# UNITED STATES PATENT AND TRADEMARK OFFICE

APPLICATION NO.	FILING DATE	FIRST NAMED INVENTOR	ATTORNEY DOCKET NO.	CONFIRMATION NO.
09/964,204	09/26/2001	Vinod Nair Gopikuttan Nair	2000 P 16657 US	1833

# Office Action Summary

FIG. 1

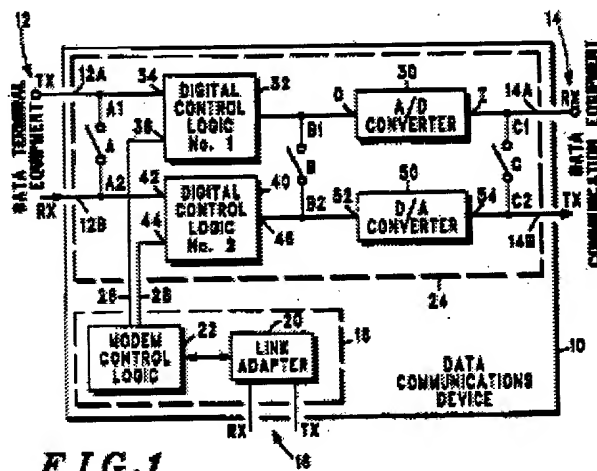
With respect to claim 1, Ray, Jr. et al ('435) anticipate a communication circuit arrangement (see Fig 1, 24) below with directional signal paths comprising:

a first signal path (14A, 30, B1, 32, 12A) to transmit a first signal into a first direction (see col. 3 lines 59-66), having an input terminal (14A) and an output terminal (12A) and including a first digital circuit block (32) (see col. 3, lines 63-64) to process the first signal.

a second signal path (12B, 40, B2, 50, 14B) to transmit a second signal into a second direction (see col. 4, lines 6-33) having an input terminal (12B) and an output terminal (14B) and including a first digital circuit block (40) (see col. 4, lines 17-18) to process the second signal and

a first switch (B) having a first terminal coupled to a first circuit node (B1) within the first signal path (14A, 30, B1, 32, 12A) and a second terminal coupled to a second circuit node (B2) within the second signal path (12B, 40, B2, 50, 14B) to provide a test signal loop (see col. 5, lines 66-68 and col. 6, lines 1-5) during a test mode of the circuit arrangement.

With respect to claim 2, Ray, Jr. et al ('435) teach that their first signal path (14A, 30, B1, 32, 12A) comprises a first analog circuit block (30) coupled between the first digital circuit block (32) and the output terminal of the first signal path (14A)

Ray, Jr. et al ('435) also teach that their second signal path (12B, 40, B2, 50, 14B) comprises a second analog circuit block (50) coupled between the second digital circuit block (40) and the input terminal of the second signal path (14B).
